JOB BALCONY NO. 2015051

CONCEPT STRUCTURAL MARK-UPS

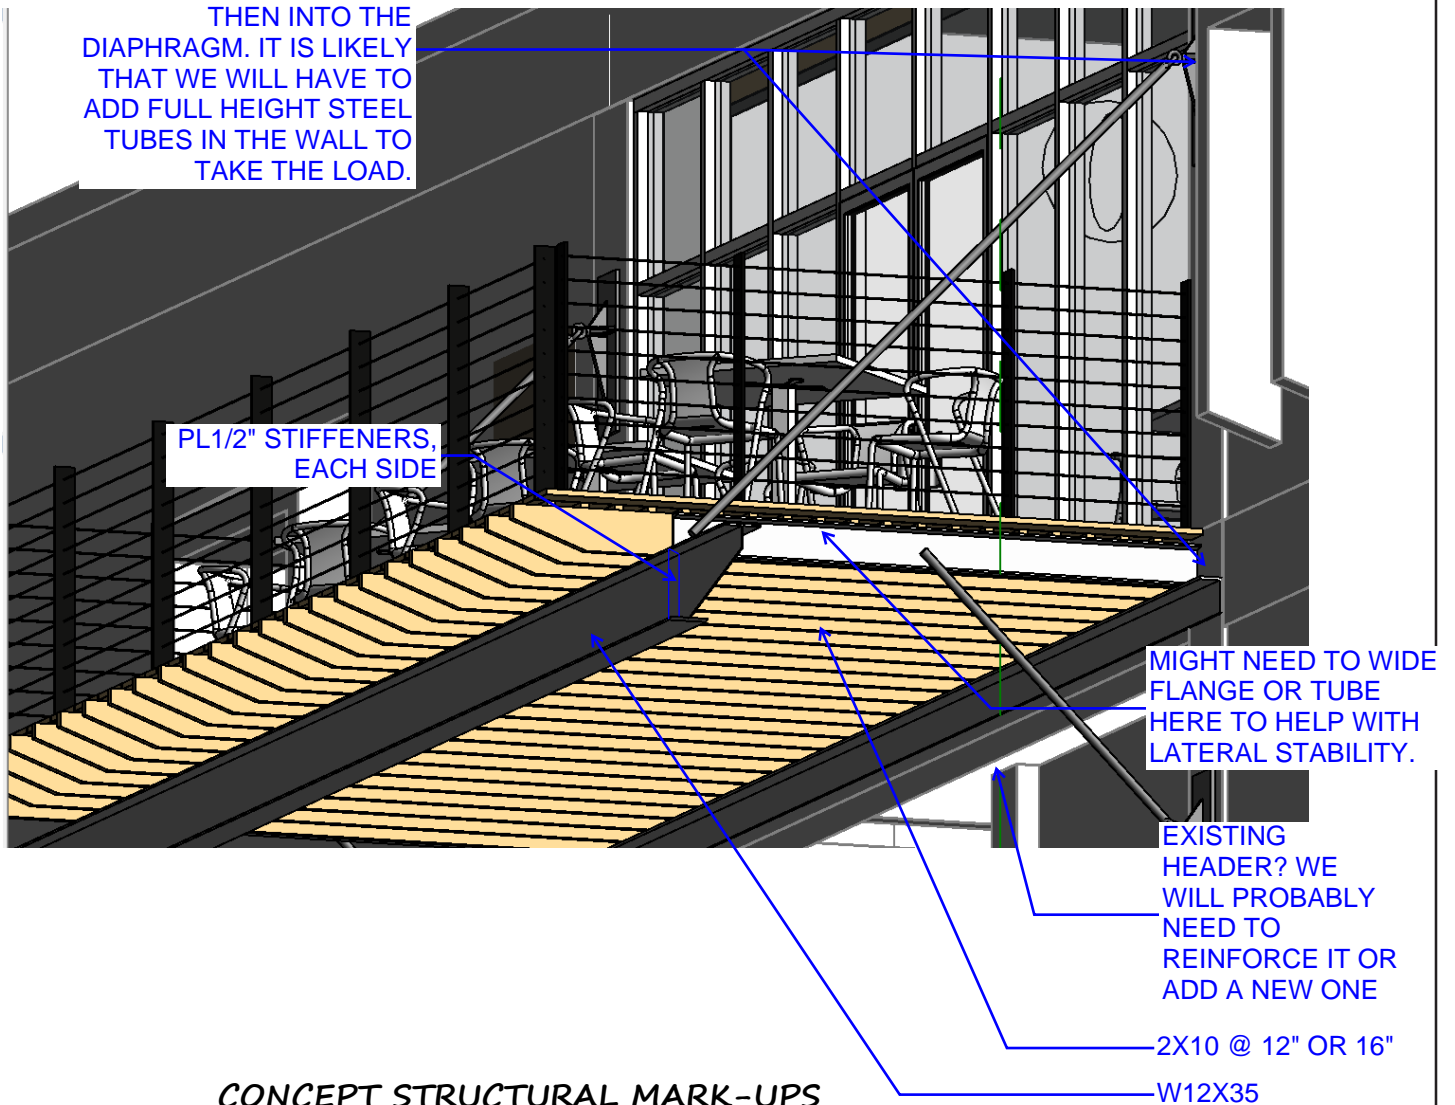
THIS PLACES A HUGE AMOUNT OF FORCE INTO THE WALL, AND THEN INTO THE DIAPHRAGM. IT IS LIKELY THAT WE WILL HAVE TO ADD FULL HEIGHT STEEL TUBES IN THE WALL TO TAKE THE LOAD.

BASED ON 100 PSF LL
